MEMORANDUM

RE: Variances for Chapter 290-5-57, Rules and Regulation for Swimming Pools, Spas and Recreational Waterparks, .10 (1) (b) Main Drain Spacing, .11 (4) Water Depths, .11 (1) Surface Skimmer Systems, .06 Decks and Deck Equipment (6) Spa Entry/Exit 6. “.10 (2) “Suction outlets, .10 (3) “Net openings in each floor outlet covering, 290-5-57-.11 (1) Surface Skimmer Systems

Action Requested: Variances on Treadmill Pool, Thermal Plunge Spa and Polar Plunge Spa

Name of Petitioner: Georgia Southern University Football Operations
205 Lanier Drive
Statesboro, GA
30458

Spa Skimmers and Filters / Strip Skimmers and Front Access Skim Filters

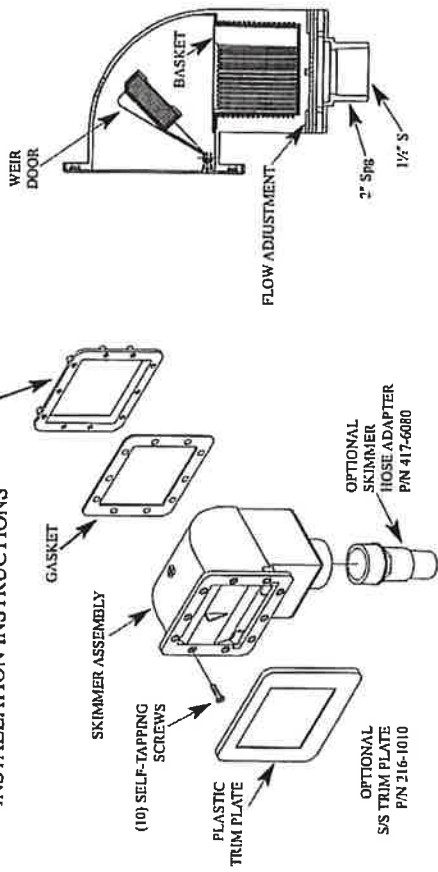
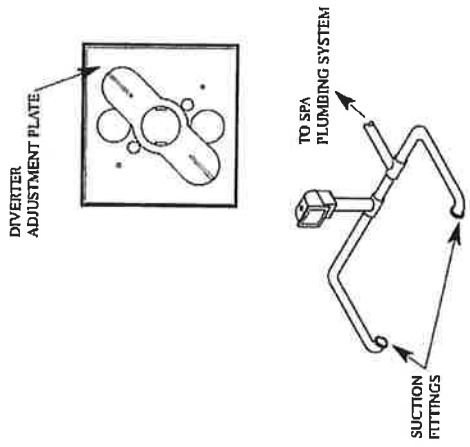
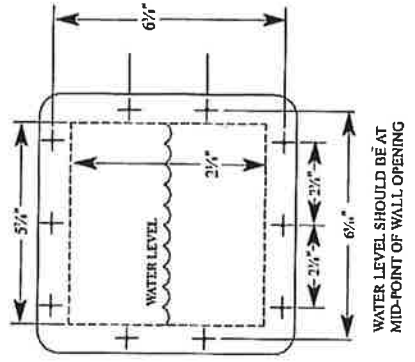
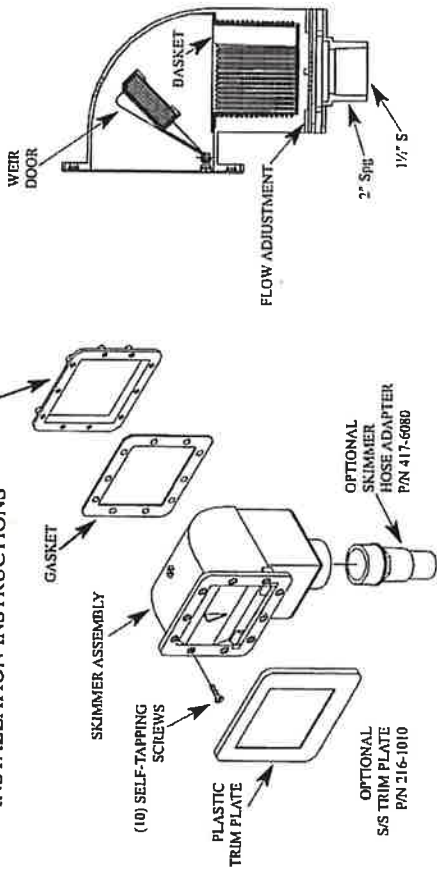
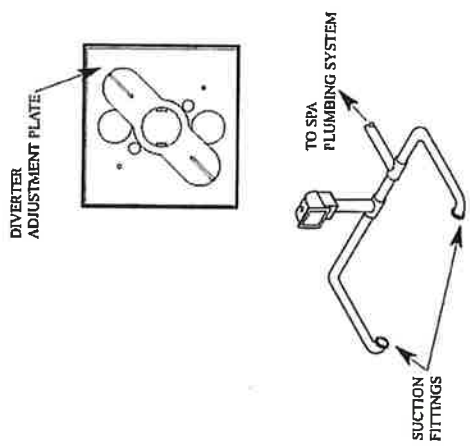
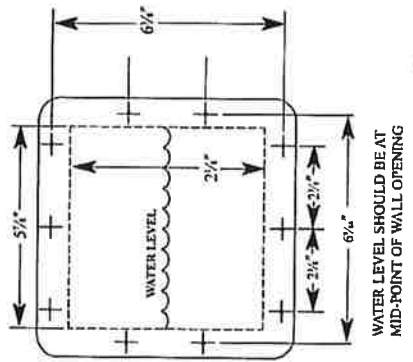
Variance: Request that skimmer not comply with NSF International Standard 50.

Installation of a NSF International Standard 50 compliant surface skimmer would lower the water level within each spa and reduce the therapeutical action the spa water would have on the user. Lower water level would reduce the spas effectiveness in promoting healing of the athletes using the spas.

Proposed spa skimmer is sized to carry 100% flow and will allow spa water level to provide maximum user coverage for the height of the spa. Proposed skimmer will be installed with an equalizer line.

Agency Decision: Section recommends Approval with Conditions

1. The designer provides written notice to the local health department in accordance with the conditions in section II. 1. and 2. above.
2. The project professional engineer provides written verification that the skimmers could meet or exceed NSF 50 or equivalent standards and are installed in accordance with the manufacturer's specifications.

SPC-3 V

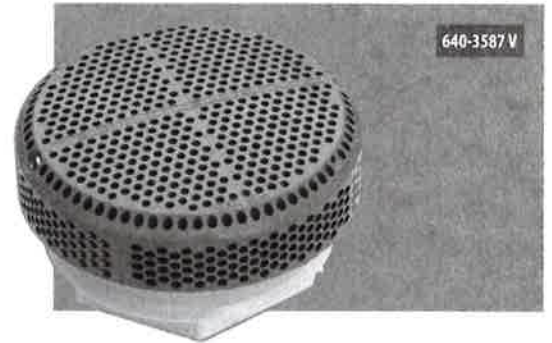
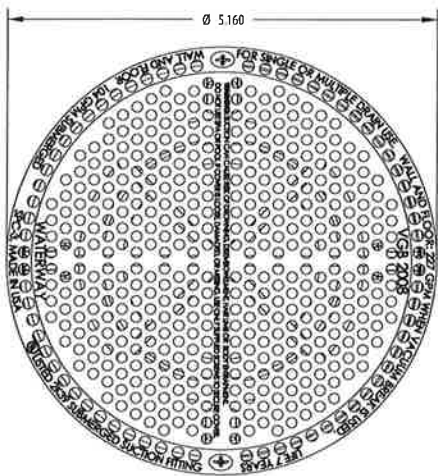
The current Swimming Pool Code for Georgia, chapter 290-5-57 was written and adopted prior to enactment of the federally mandated Virginia Graeme Baker Pool and Spa Act (VGB) which is now in effect. This Act essentially requires that all suction outlets in pools and spas shall be provided with an entrapment preventive covers.

Every suction outlet in the proposed two spas and treadmill pool will have a VGB-compliant suction outlet cover which may not meet the Georgia Chapter 290-5-57 code but must be installed per federal mandate. These VGB-compliant covers meet or exceed the intent of the anti-entrapment function of the Georgia code.

The VGB-compliant suction covers have been tested to meet federal standards to prevent underwater entrapment by persons including small children. The proposed pools will be used in a controlled environment supervised by University staff and immersion will only be by University athletes. The VGB-compliant suction covers meet or exceed the Georgia code to prevent entrapment by persons at suction outlets.
